# TECHNICAL NOTE

**TECHNICAL NOTE NUMBER:** 03

**SUBJECT:** Multi-function fauna barriers south of Governor Road

Figure 1: Location and extent of multi-function fauna barriers and noise walls proposed south of Governor Road in the reference design for the project

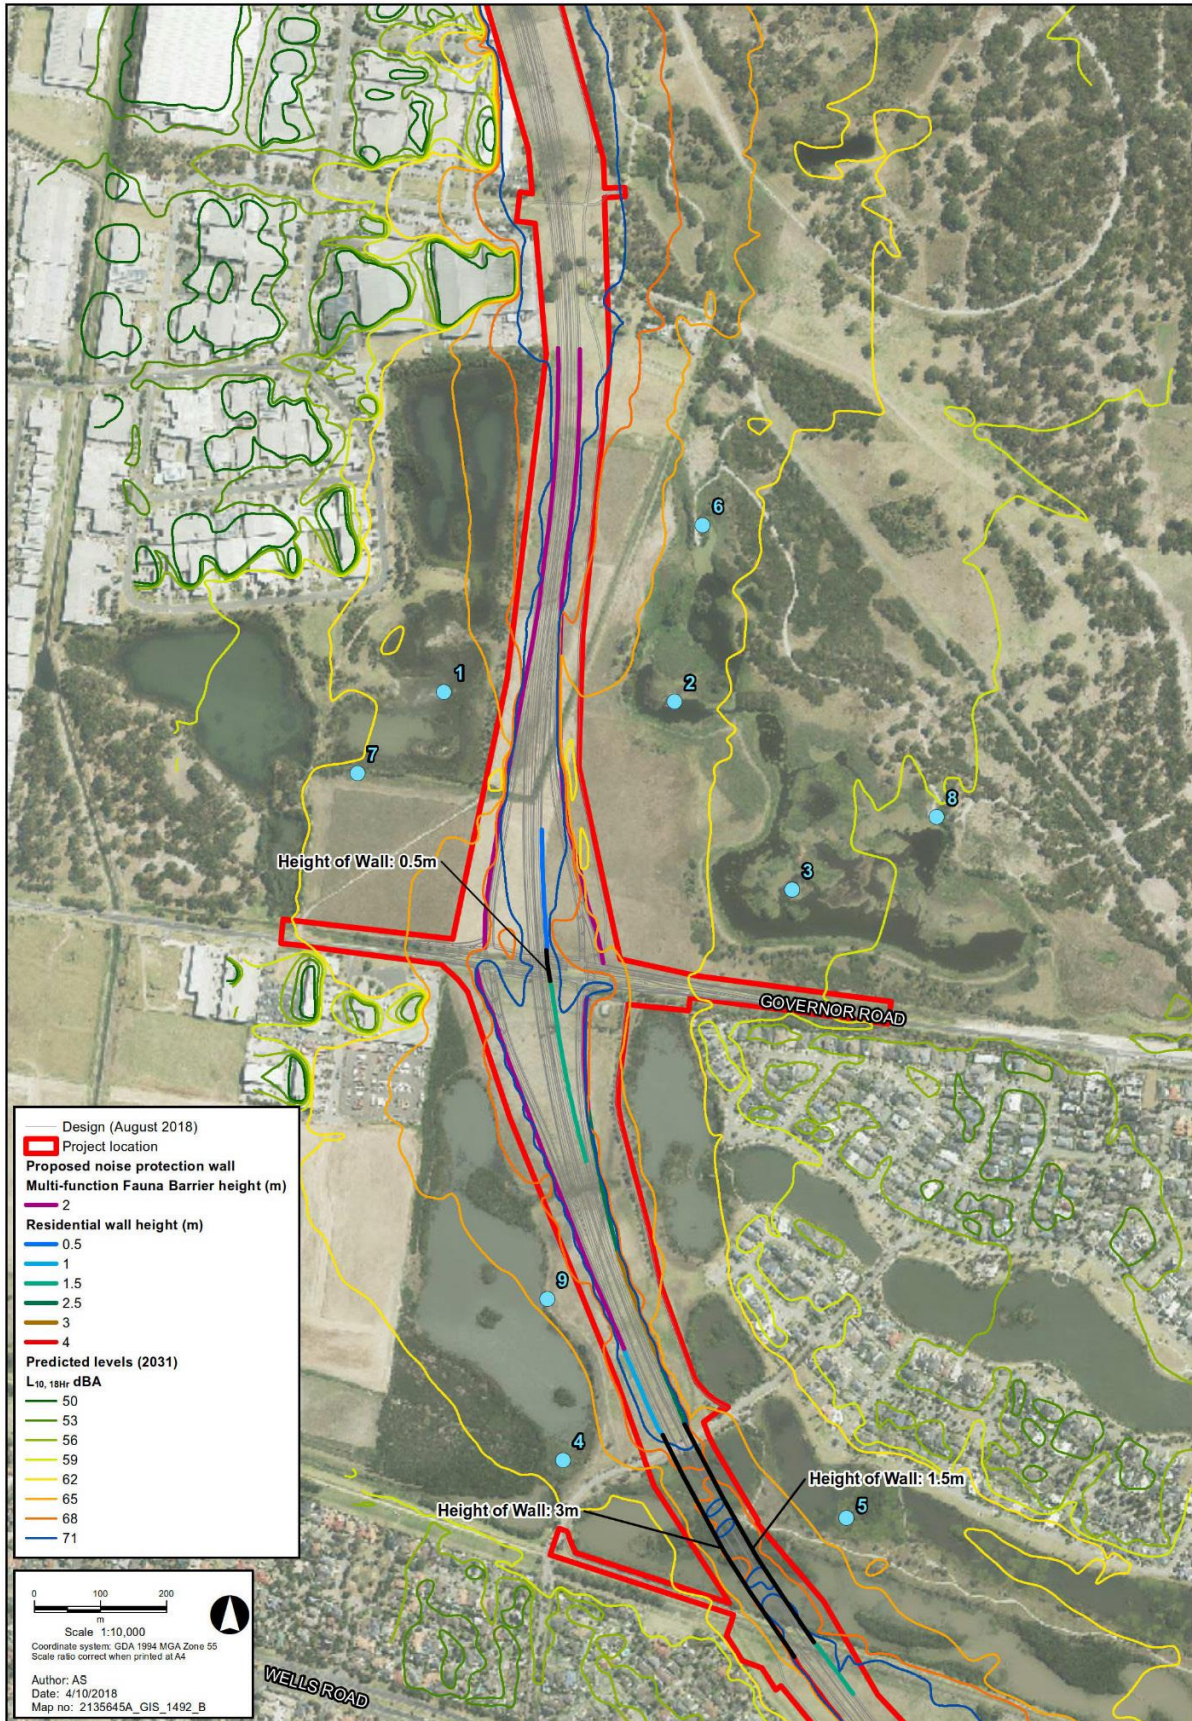
1. The reference design for the project included multi-function fauna barriers as well as noise walls along sections of the project alignment between Governors Road and the Melbourne Water levy to the south, as follows:

- a. **Waterways Wetlands (north-west):** on the west side of the new roadway, provision of a 2 metre high multi-function fauna barrier extending from Governor Road to the south approximately 600 metres, transitioning to a 1 metre high noise wall to be provided from that location to Bowen Park Way

- b. **Waterways Wetlands (north-east):** on the east side of the new roadway, provision of a 2 metre high multi-function fauna barrier extending from Governor Road to the south approximately 200 metres, transitioning to a 2.5 metre high noise wall to be provided from that location to the south approximately 175 metres, transitioning to a 3 metre high noise wall to be provided from that location to the south approximately 200 metres, transitioning to a 2.5 metre noise wall to be provided from that location to Bowen Park Way

- c. **Waterways Wetlands (bridge structure):** provision of a 3 metre high noise wall on the western side of the new western roadway bridge structure extending from Bowen Park Way south to the Melbourne Water Levy, and provision of a 1.5m metre high noise wall on the eastern side of the new eastern roadway bridge structure extending from Bowen Park Way south to the Melbourne Water Levy

2. The location and extent of the multi-function fauna barriers and noise walls are depicted in Figure 7.2 on page 188 of the main report of Annexure C to the EES, which is extracted as Figure 1 below.

- a. **Waterways Wetlands (north-west):** on the west side of the new roadway, provision of a 2 metre high multi-function fauna barrier extending from Governor Road to the south approximately 600 metres, transitioning to a 1 metre high multi-function fauna barrier to be provided from that location to Bowen Park Way

- b. **Waterways Wetlands (north-east):** on the east side of the new roadway, provision of a 2 metre high multi-function fauna barrier extending from Governor Road to the south approximately 200 metres, transitioning to a 2.5 metre high multi-function fauna barrier to be provided from that location to the south approximately 175 metres, transitioning to a 3 metre high multi-function fauna barrier to be provided from that location to the south approximately 200 metres, transitioning to a 2.5 metre multi-function fauna barrier to be provided from that location to Bowen Park Way

- c. **Waterways Wetlands (bridge structure):** provision of a 3 metre high multi-function fauna barrier on the western side of the new western roadway bridge structure extending from Bowen Park Way south to the Melbourne Water Levy, and provision of a 3 metre high multi-function fauna barrier on the eastern side of the new eastern roadway bridge structure extending from Bowen Park Way south to the Melbourne Water Levy

4. The differences between multi-function fauna barriers proposed south of Governor Road as part of the reference design and as part of MRPV's Version 2 EPRs are summarised below:
  - a. **Waterways Wetlands (north-west):** the wall heights and lengths are unchanged, however, the 1 metre high noise wall is now to be specified in EPR B1 as a multi-function fauna barrier;
  - b. **Waterways Wetlands (north-east):** the wall heights and lengths are unchanged, however, the noise walls are now to be specified in EPR B1 as multi-function fauna barriers
  - c. **Waterways Wetlands (bridge structure):** the noise walls are now to be specified in EPR B1 as multi-function fauna barriers, and the height of the multi-function fauna barrier on the east side of the new eastern roadway bridge structure is increased by 1.5 metres so that it is now proposed to be 3 metres high
